Appl'n No: 09/807,634  
Amdt dated March 19, 2004  
Reply to Office action dated November 19, 2003

**AMENDMENTS TO THE DRAWINGS:**

Fig. 11

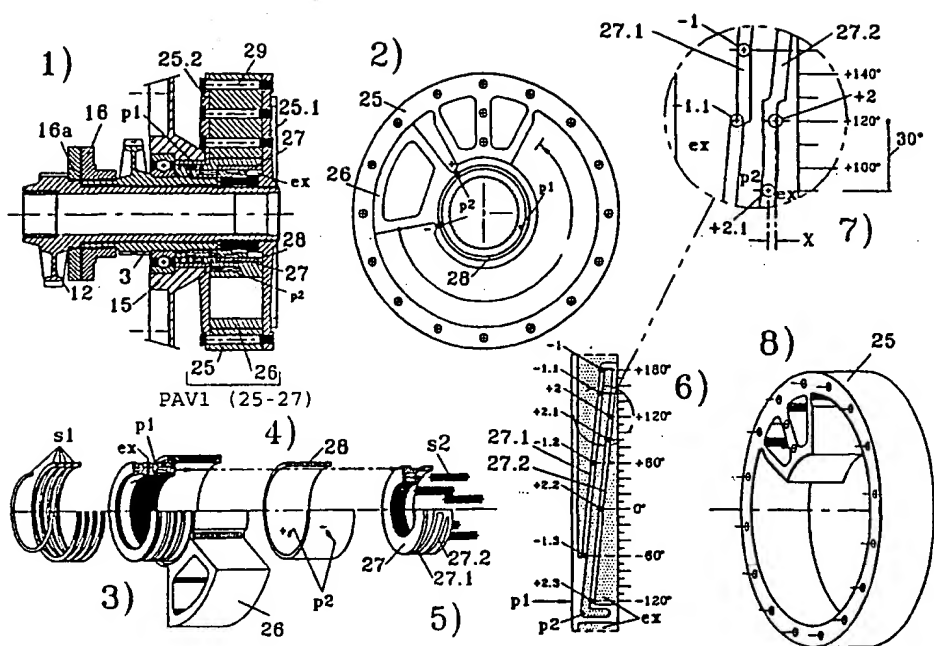
The attached sheets of drawings include changes to Figures 11, 11a, 11b, 12, 13b, 14 and replaces the original sheet of the same Figures. In each of the noted Figures, the phase angle variator as set forth in the claims has been shown in the drawings.
